Subject: Class 3 Permit Modification Request for the Waste Isolation Pilot Plant Hazardous Waste Facility Permit, Number NM4890139088-TSDF

Comments Class 3 Permit Modification Request  
Addition of a Concrete Overpack Container Storage Unit  
Waste Isolation Pilot Plant  
Carlsbad, New Mexico  
WIPP Permit Number - NM4890139088-TSDF  
September 2016  
George Anastas, PE, CHP, BCEE, FHPS, FARPS

Item 7 Response: The Big Red T-450S/T520S Taylor Industrial Trucks Standard Specifications

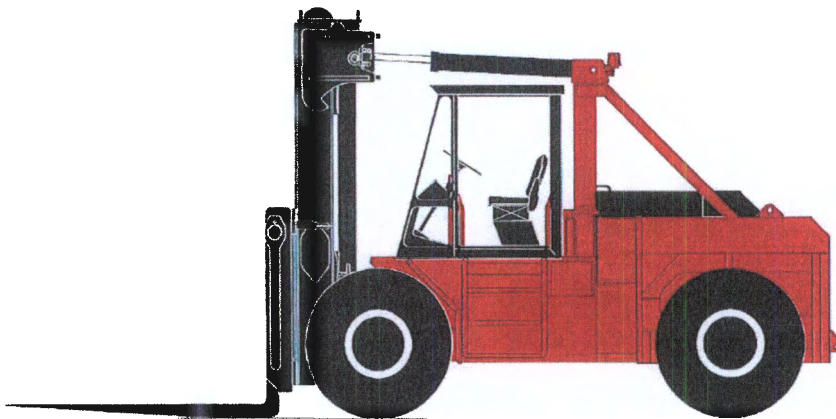
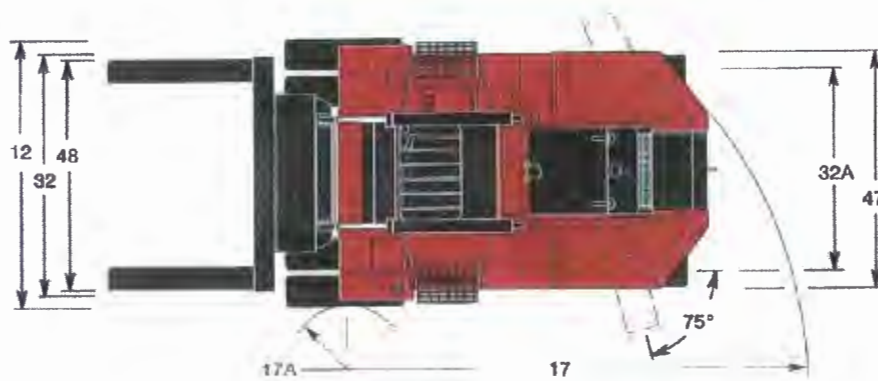
Item 7 Page 7: The Request states: “The Overpack Unit will be configured to provide safe driving paths for forklifts handling concrete overpacks.” And states on page D-4: “Aisles providing area access and egress paths shall be 48 inches minimum.” And states on page 9 ” Access space will be provided between stored concrete overpacks to allow access for personnel performing inspections and by Fire Department personnel as needed.

cut sheet (Attachment A to the Request) indicates the width of the proposed industrial truck (forklift) is 120 inches and the minimum outside turning radius is 198 inches.

Aisles providing area access and egress paths of 48 inches minimum might make it difficult to move forklift along the aisles. What is the minimum width of the egress path required by Fire Department Personnel?
